Document Information			
Document #	RPP-24544	Revision	1D
Title	DEMONSTRATION BULK VITRIFICATION SYS INDEPENDENT QUALIFIED REGISTERED PROFESSIONAL ENGINEER (IQRPE & RCRA DESIGN REVIEW PACKAGE		
Date	05/11/2006		
Originator	SHUFORD DH	ORG CO	CH2M
Recipient		Recipient Co.	
References	ECN-723118-R5, RPP-24544-R0, RPP-24544-R1, RPP-24544-R1A, RPP-24544-R1B, RPP-24544-R1C, EDT-821657, ECN-723118-R0, ECN-723118-R1, ECN-723118-R3, ECN-723118-R4		
Keywords	SUPPL TREATMENT		
Projects

Appendix C5

APPENDIX C5

MAIN OFF-GAS TREATMENT SYSTEM

TRI-WEB SCRUBBER
FOUNDATION #11 - PLAN

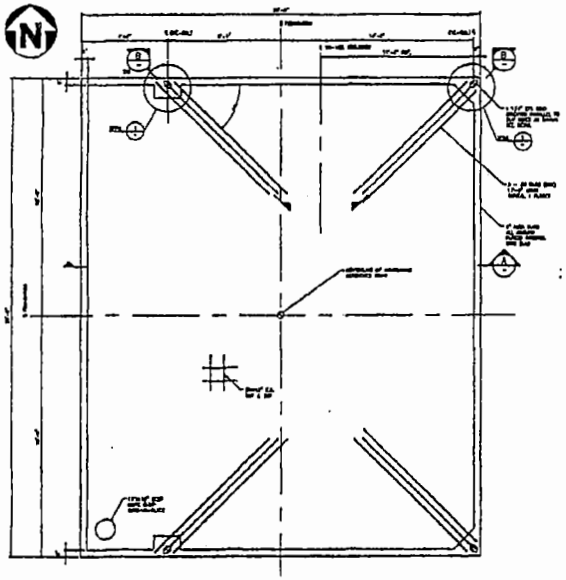
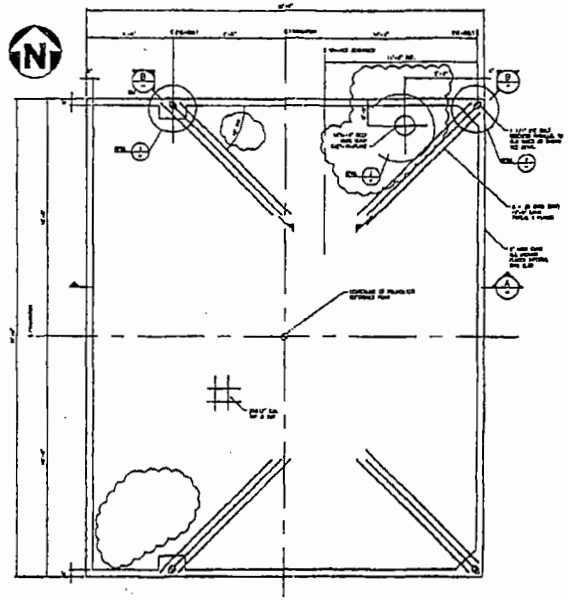
1. Revise the TRI-MER Scrubber Foundation #11 - Plan located in Zone D-7 to relocate the sump from the southwest location on the slab to the northeast location, as shown on Sheet 4 of this ECN.

2. Add rebar at the revised sump location, as shown on Sheet 4 of this ECN.

3. Revise the text font for the angle showing the orientation of the special rebar located at the lifting points, as shown on Sheet 4 of this ECN.

OFF-GAS STACK
FOUNDATION #10 – PLAN
1/4"=1'-0"

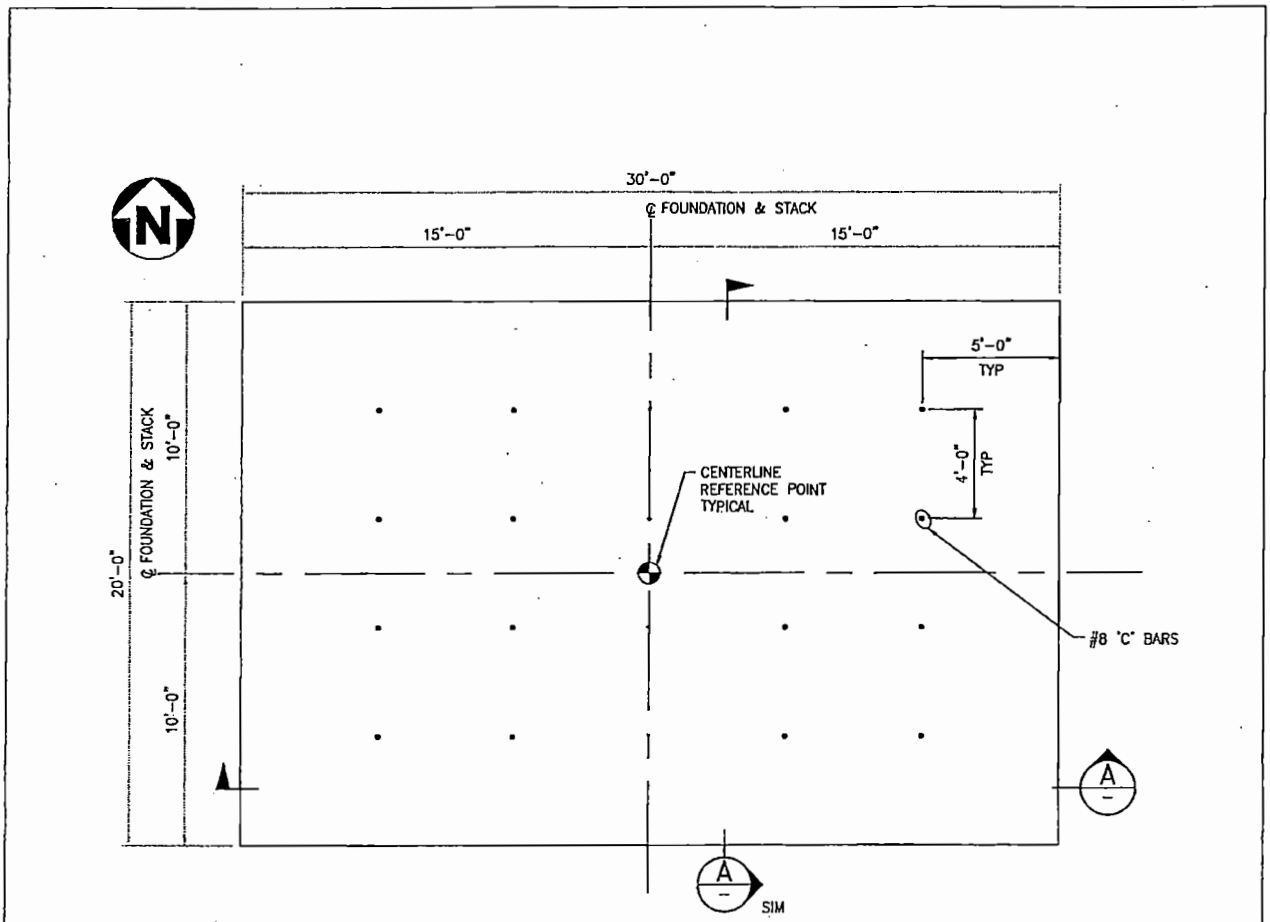
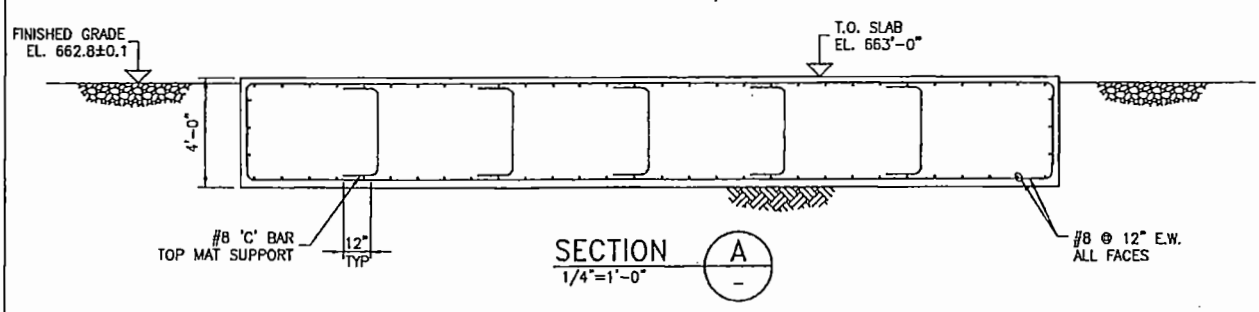
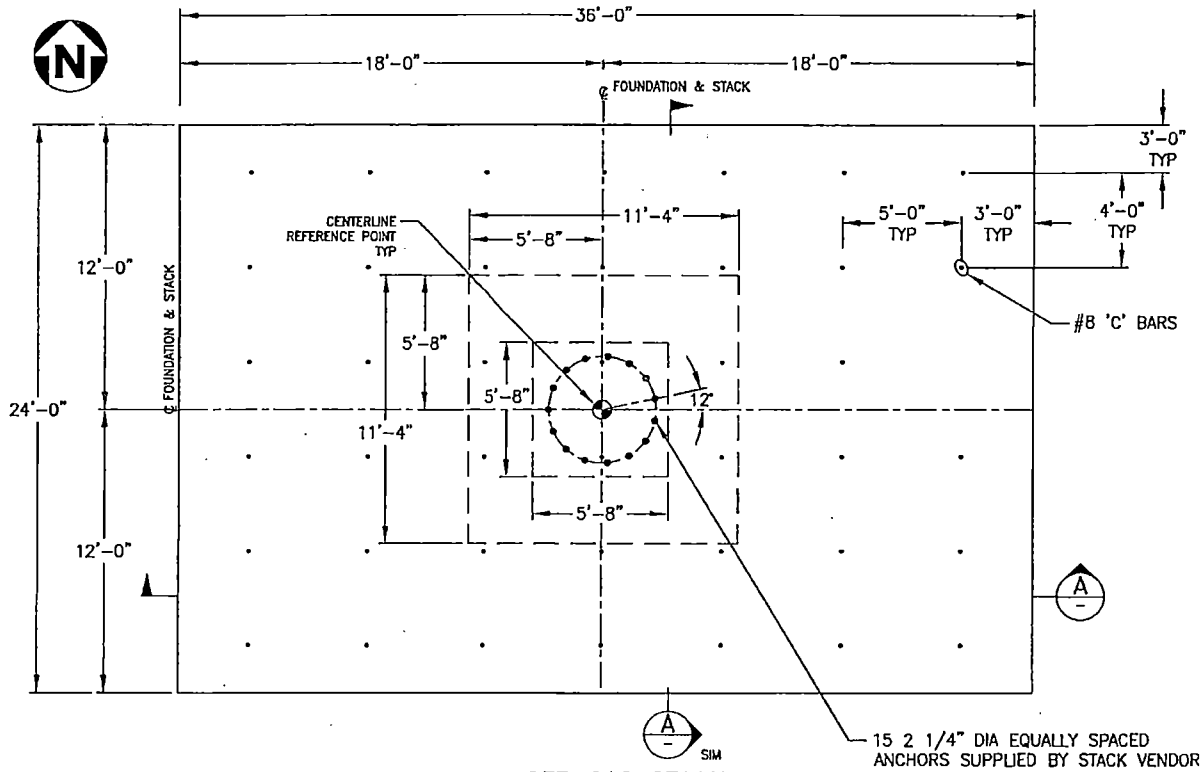
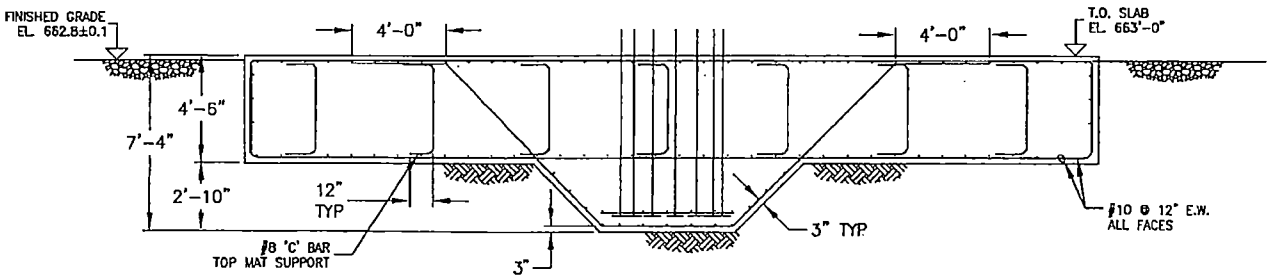
The current design of the OGTS Stack foundation, shown on drawing H-14-106796, revision 0, requires the dimensions of the foundation to be 20'-0" x 30'-0" x 4'-0" deep. Subsequent analysis and design completed for the OGTS Stack by the vendor requires an increase in the size of the foundation. The revised plan dimensions of the foundation increased to 24'-0" x 36'-0" to accomodate the larger area required for the layout of the OGTS Stack and exhaust fans. The increased depth to 7'-4" and revision of the foundation reinforcing steel is required to accommdate the anchorage for the OGTS stack and satisfy structural requirements.

1) Revise the drawing plan and section for OGTS Stack foundation #10 to provide the revised dimensions and reinforcing steel requirements, as shown on sheet 4 of this ECN.
